HYDER HARBOR IMPROVEMENTS

AIP NO. 3-02-0382-0102 ~ 68198

AS BUILT DRAWINGS
Contractor: Western Marine Const. Inc.
Project Engineer: Al Risley
Begin Const: August 8, 2003
Completion Date: September 18, 2003

Seaplane Float Decking Plan

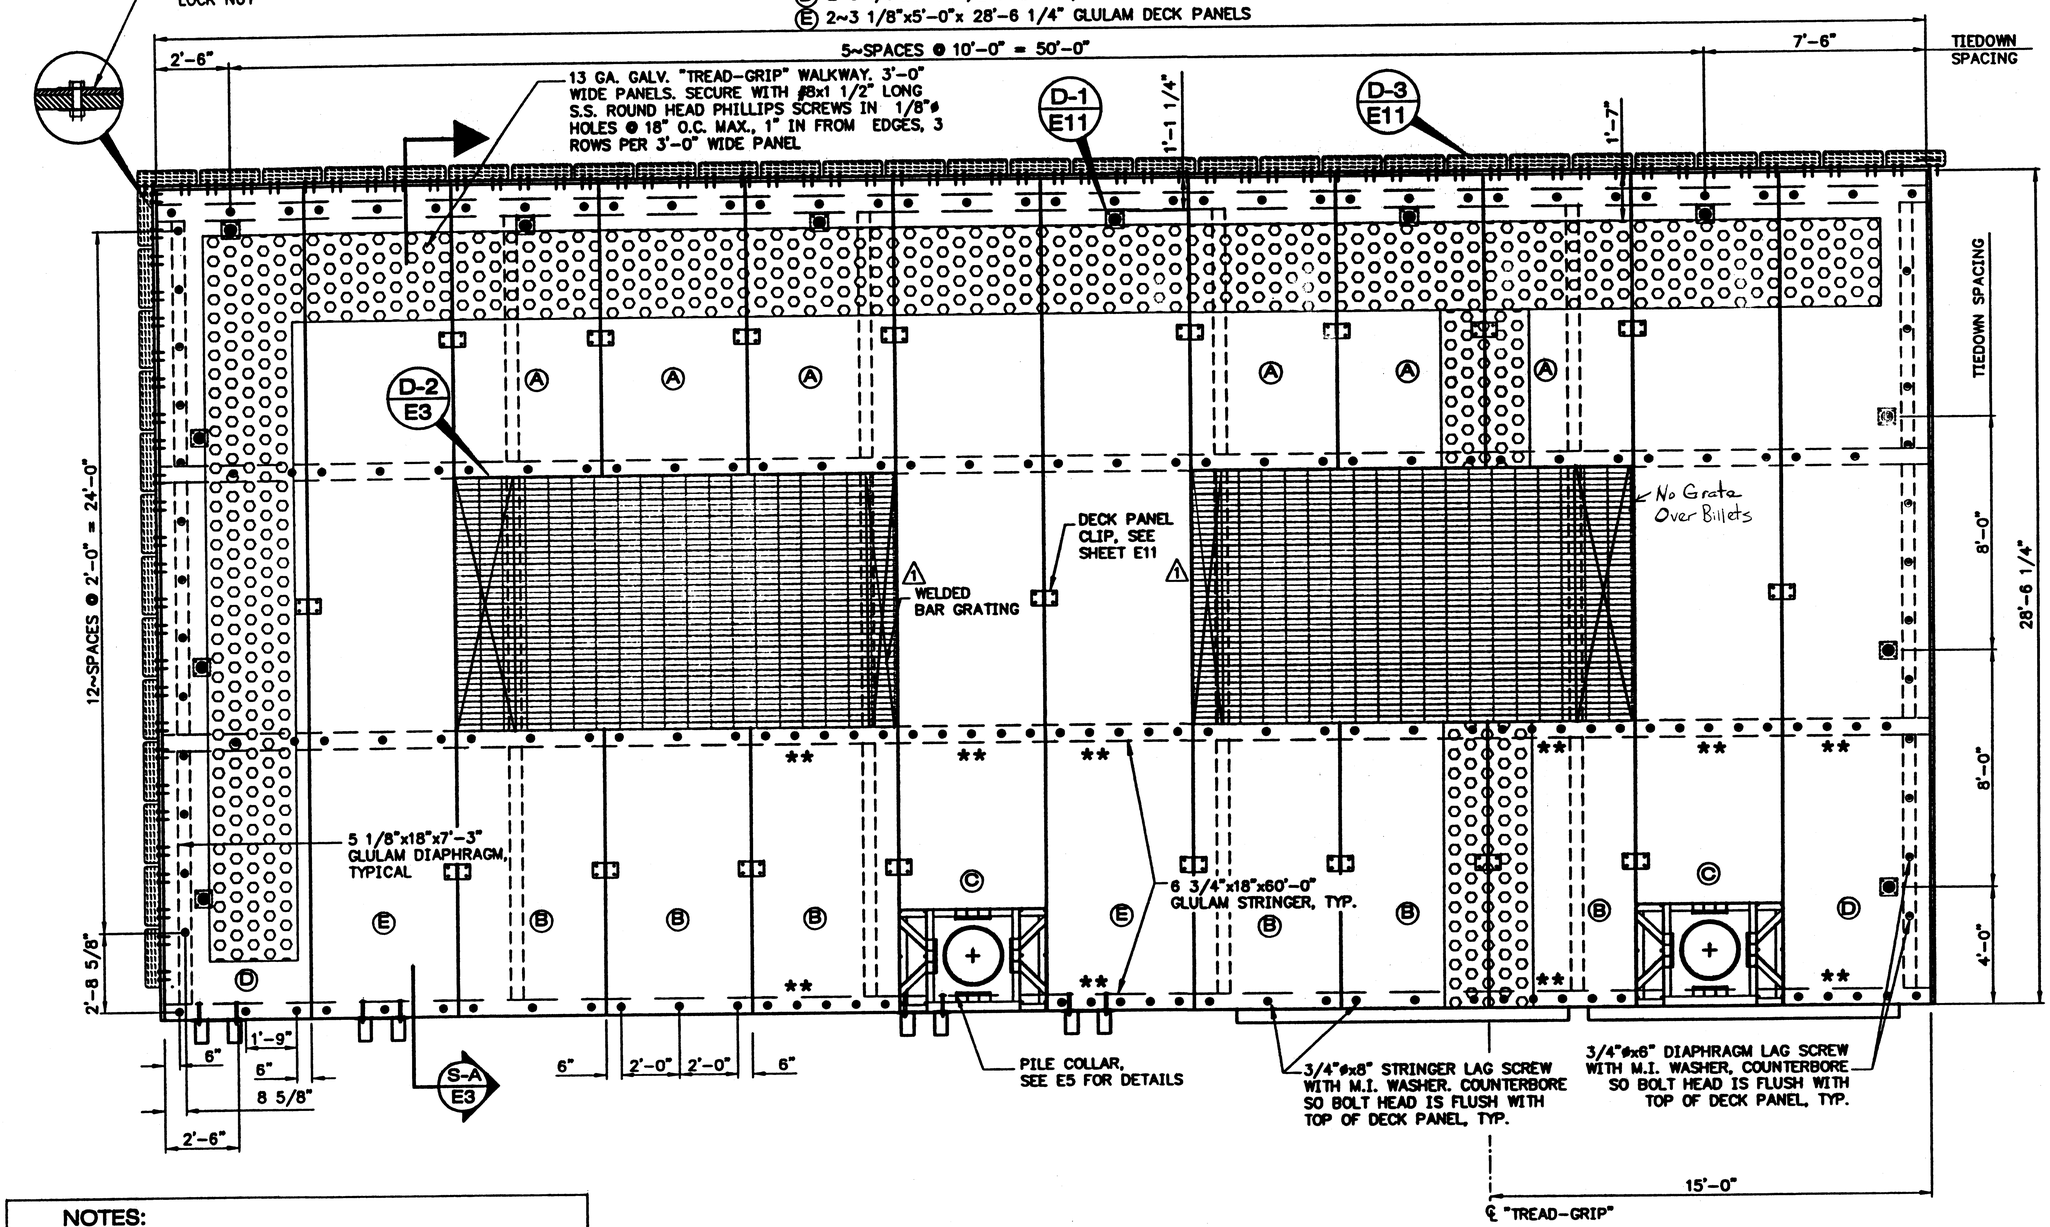
No.	DATE	DESCRIPTION
1	4/24/02	Grating Per NMFS and U.S. Fish & Wildlife.

Launch Ramp Profile & Details

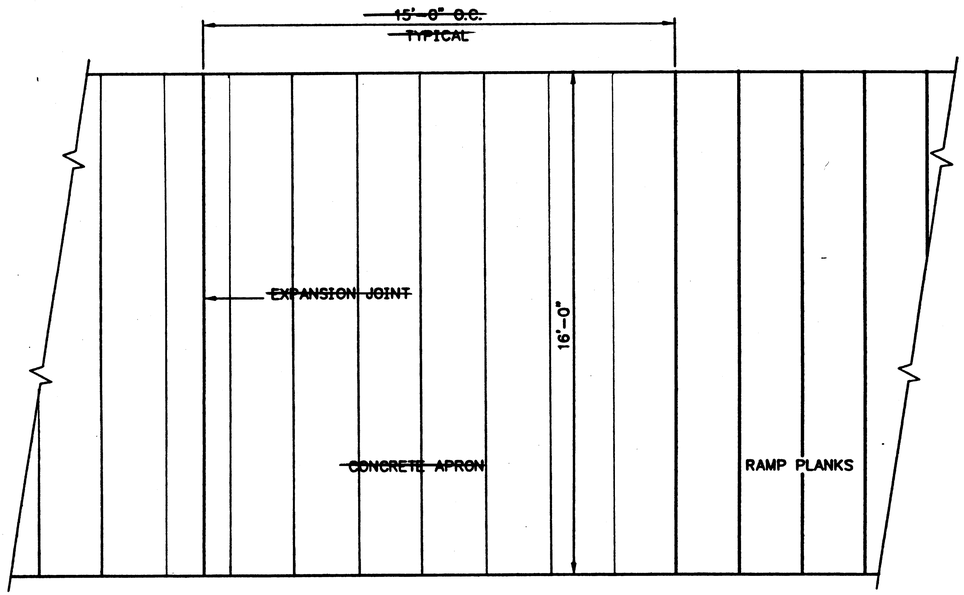
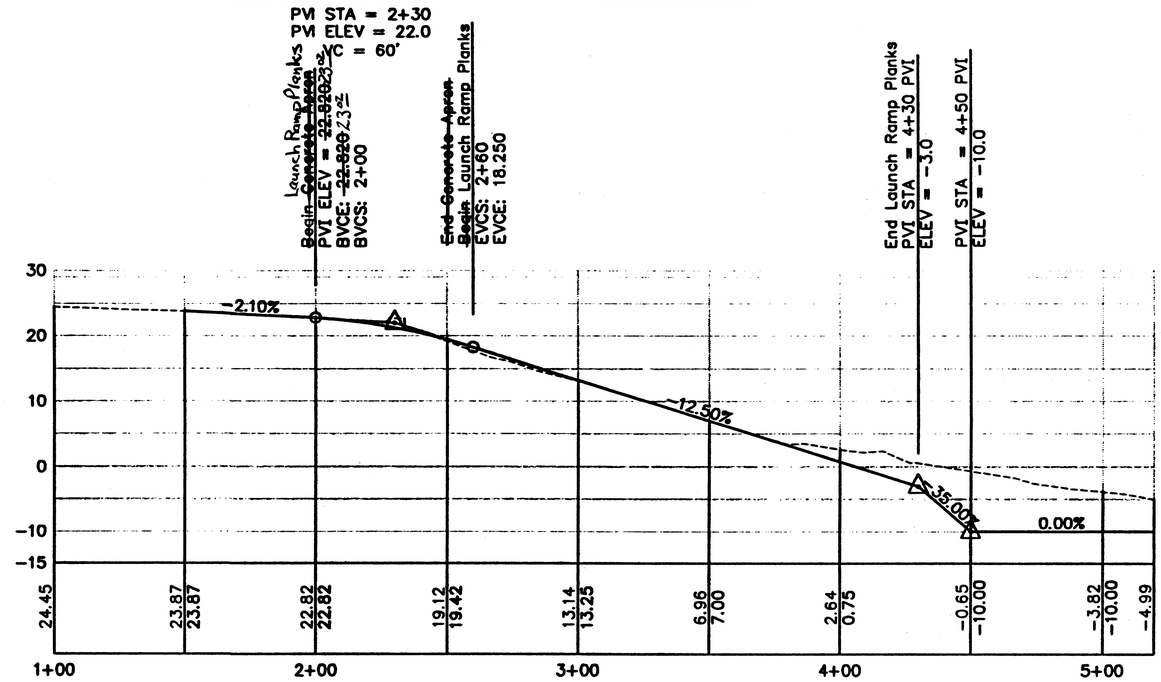
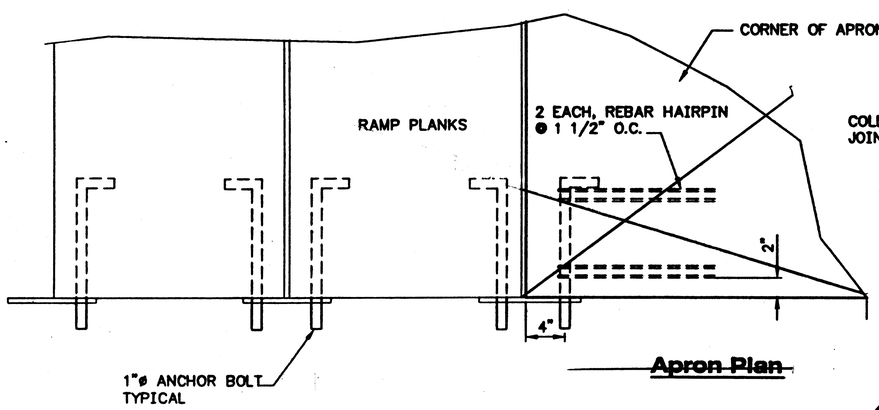
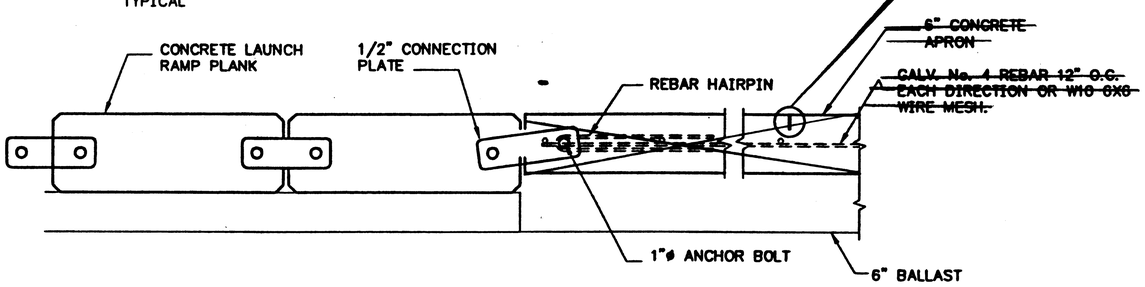
~~**Apron Plan**~~

~~**Sawed Expansion Joint Typical Section**~~

1. ~~REBAR ALONG EDGE OF APRON SHALL HAVE MINIMUM COVER OF 2".~~
2. ~~ALL TOP EDGES OF APRON SHALL BE CHAMFERED 1/2".~~
3. ~~TOP OF APRON SHALL BE ROUGH BROOM FINISHED.~~

~~**Plank To Apron Connection Detail**~~

~~**Rebar Hairpin**~~
~~8 EACH~~

~~**Connection Plate**~~
~~TOP PLANK TO CONCRETE APRON~~
